ADDENDUM #1
Wahoo & Kingfish Piers Electrical Upgrades
Invitation to Bid: ITB 005-16
February 18, 2016

ADDENDUM #1
Wahoo & Kingfish Piers Electrical Upgrades
Invitation to Bid: ITB 005-16
February 18, 2016

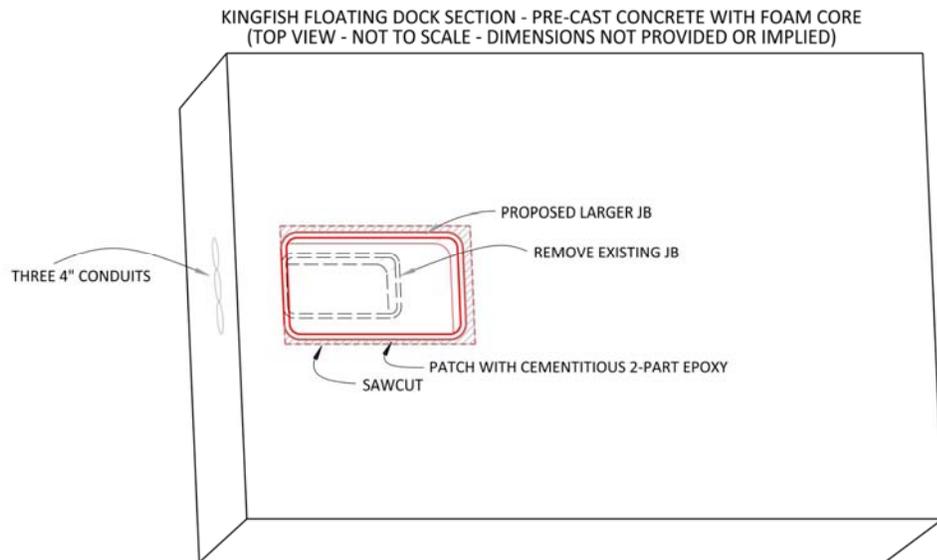
Q Please describe the “substantial work” required in the first junction box on Kingfish Pier.

A The existing junction box is too small to accommodate the number of required splices as this is a transition point between DLO or G-type cables and XHHW2 cables for all conductors coming from the MDP. The floating dock manufacturer has recommended replacing the junction box with a larger size by saw-cutting surrounding concrete, patching and embedding the new vault using two-part cementitious epoxy. Sawcuts should avoid all corners to avoid reinforcing steel. Cuts should be made only in the flat top section. For illustrative purposes only, please see the below diagram:
